## Subject: FLOW DIVERSION FROM STREET GUTTER TO SIDEWALK AND SHARED USE PATH

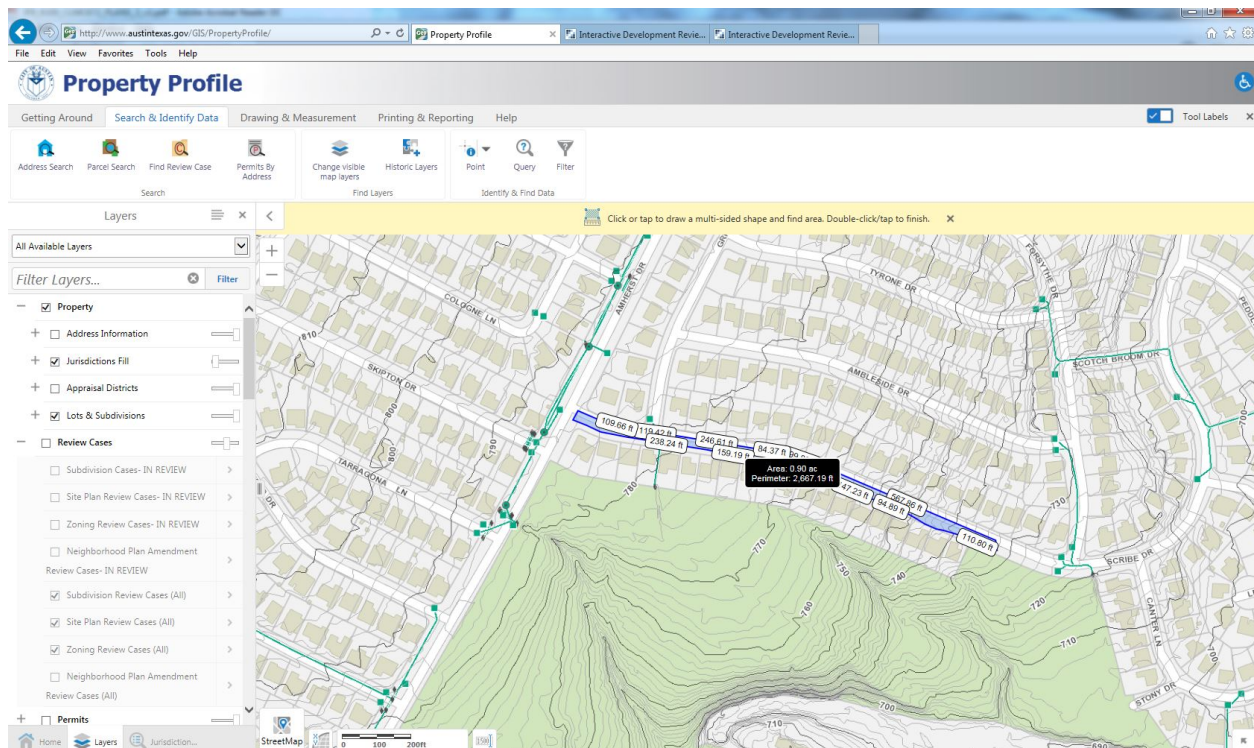
The installation of an accessible ramp on Scribe has resulted in allowing stormwater that was previously conveyed in the street gutter to a curb inlet is now directed along the accessible sidewalk connection to the shared use path where it is causing excessive erosion. We estimate that approximately 0.90 acres containing 1320 feet of roadway drains to the point where it escapes the curb. We estimate the 25 year peak flow from this approximately 7 cfs. In addition to causing erosion of the trail, this condition violate good engineering practice and City of Austin Drainage Criteria. Criteria Violated are highlighted below.

Closer view of site and drainage area

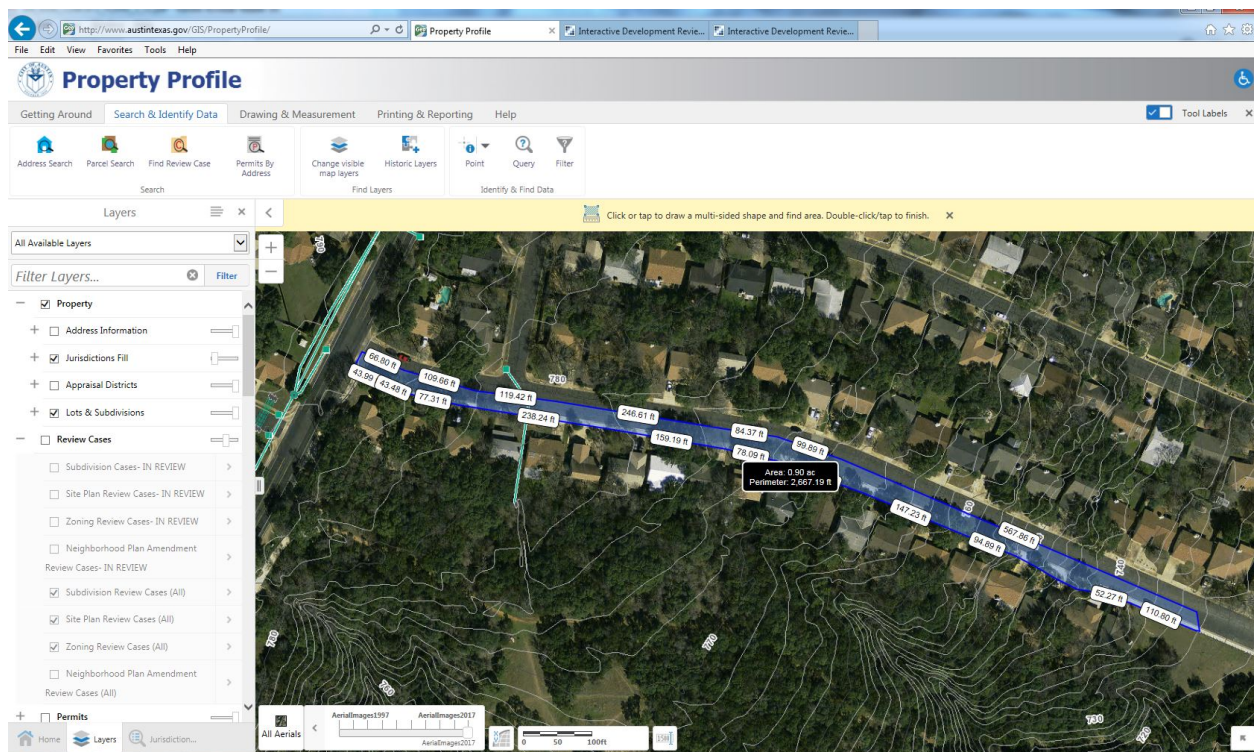
D. Concentrated discharge across a sidewalk area will not be allowed. A channel section can be used under the sidewalk area, provided the outlet device utilizes sheet flow methods, maintains a minimum three (3) foot horizontal separation from all utility infrastructure, and it is covered by a method approved by the Public Works Department.
